Technical Information				Date: Official: Department:	11.07. Narin ST-FIF	2017 R/MKP1.1			
				0.1.7					
	nformati	on No.	2120/2						
Subjec	ct:		Revised	EN 54-13:2017					
Short	Descripti	on.	Drop of	requirement "creep	oing onon/shor	<b>+</b> 11			
Siloit	Descripti	OII:	DIOP OI	requirement creek	oning openion				
Hardw	ware 🛛 🗎 Devi			ce 🛮 🖾 Module			□РСВА		
Softwa				cation	Driver / Ex	tension	Firmwa	Firmware	
		_	<u> </u>	L	<u> </u>				
Affect	ed Produ	cts (detai	ils)	CTN	SAP no.		Aff. version	New version	
System	n FPA-50	00							
System	n FPA-12	00							
System	n FPA-11	00							
FPP-50	000								
FPC-5	00								
UGM-2	2040								
UGM-2	2020

In May 2017 the revised EN 54-13:2017 was released.

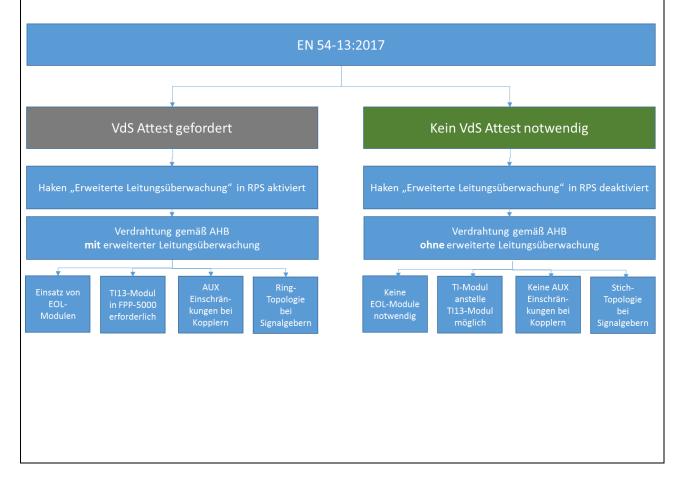
Field element installations are now simplified:

- no EOL modules required anymore
- TI module instead of TI13 module for FPP-5000 is sufficient
- AUX outputs of all interface modules (e. g. FLM-420/4-CON) can now be used
- stub topology for notification appliances possible (instead of ring topology)
